City of Portland, Maine – Building or Use Permit Application- 389 Congress Street, 04101, Tel: (207) 874-8703, FAX: 874-8716

Subject: 64 Lester Street, Portland, Maine

SHELLEY ENGINEERING, INC. STRUCTURAL CONSULTANTS 90 BRIDGE STREET WESTBROOK, MAINE 04098 PHONE (607) 854-6465 FAX (207) 854-8708	CONNECTOR ADDITION AT 64 LESTOR ST. PORTLAND, MAINE		
	Proposed By YES	Date 4/26/00	Project No. SK-1
Checked By TCS	Status NOTED	Scale 2000-119

BUILDING PERMIT REPORT

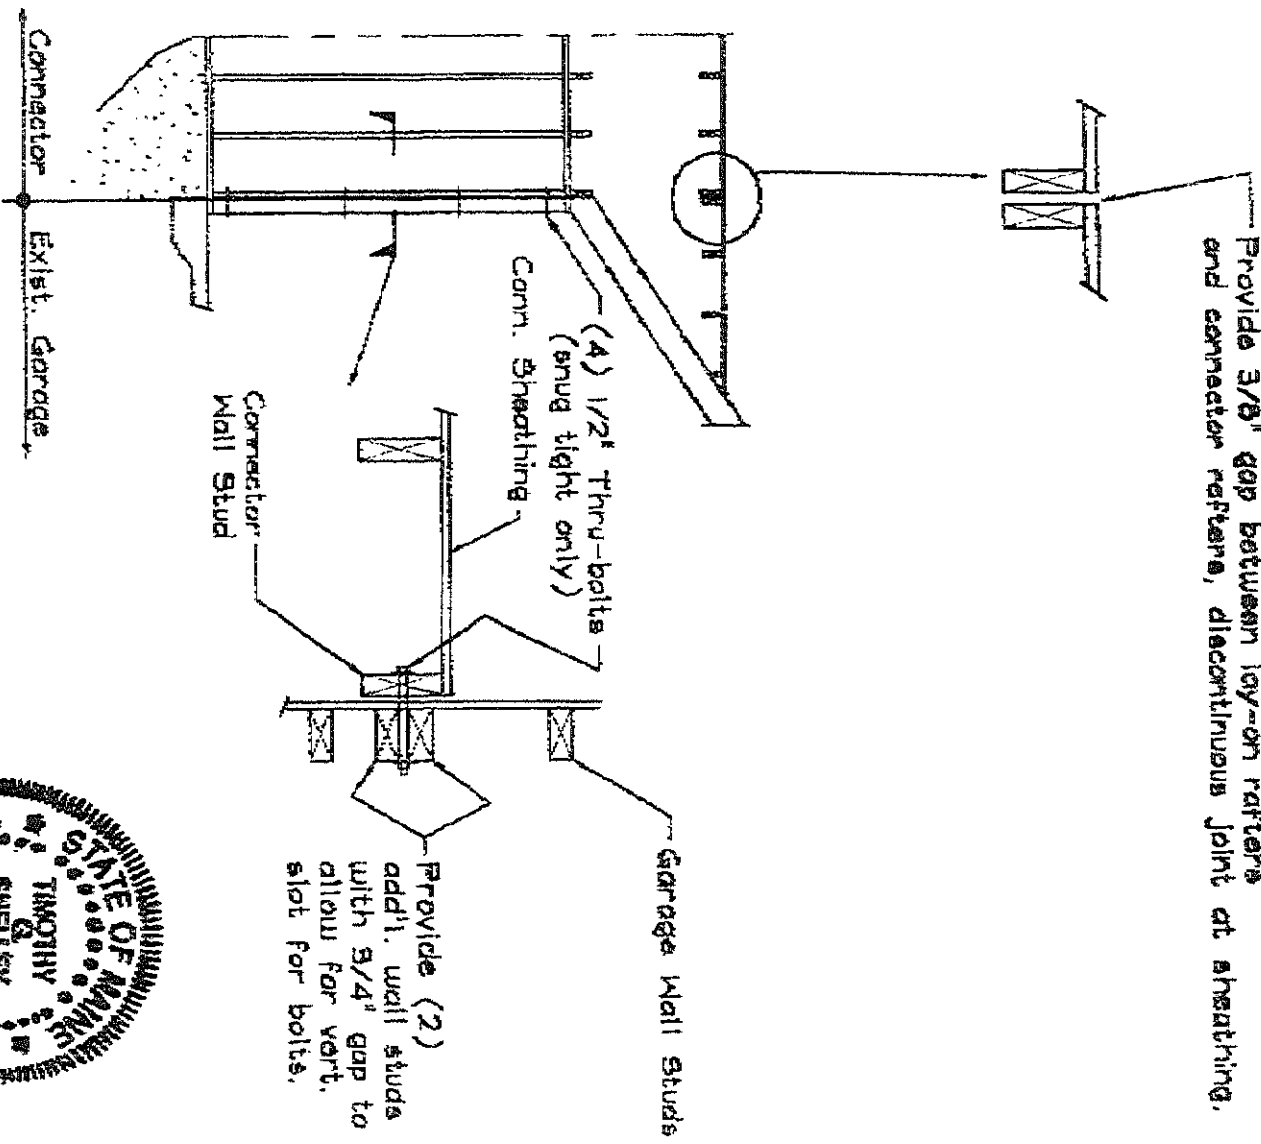
35. All signage, shall be done in accordance with Section 3102.0 signs of the City's Building Code, (The BOCA National Building Code/1999).
- IF THE GARAGE IS NOT ON A TRAIL WALL OR FULL FOUNDATION THE CONNECTOR SHALL BE DESIGNED AND PRIVATE NO WORK IS TO BE DONE UNTIL THIS DESIGN HAS BEEN SUBMITTED AND APPROVED. THE DESIGN SHALL BE DONE BY A STRUCTURAL ENGINEER.*

4/25/00 Hole dug - no frost wall on foundation under spigot - with hole to
 four engineered concrete done by design professional per spec. 36 of
 C.A.B. approval. Noted Mr. Seale via page 228-291 & noted his security
 @ 774-4755 - No comment passed until in compliance w/ spec #36 P
 4/25/00 Called w/ Mr. Seale - he will be forwarding the documents required under #36 P
 4/27/00 documents rec'd, forwarded to P.S.H. for review (1) 4/27/00 #36 approved by P.S.H.
 5/1/00 - Framing - OK

- 1.0) Construct the connector walls on concrete frost walls. Isolate the frost walls from the garage foundation by providing a 1/2" compressible filler between the new and existing concrete.

- 2.0) Build the lay-on framing of the connector roof directly on the garage roof framing. Where the connector roof meets the lay-on framing, stop and start the roof framing and sheathing, leave a 3/8" gap between the two. I recommend installing ice and water-shield over this gap, from eave to eave. The roof shingles can then span the gap.

- 3.0) Where the connector wall studs meet the garage wall a detail for allowing vertical movement, but preventing horizontal movement is required. This can be accomplished in the means in which the two are attached. I recommend bolting the connector wall to the garage wall, placing the bolts in vertically slotted holes. The holes will permit vertical movement, but not horizontal movement. I have attached a sketch illustrating these concepts.

Provide 3/8" gap between joist-on rafters and connector rafters, discontinuous joint at sheathing.
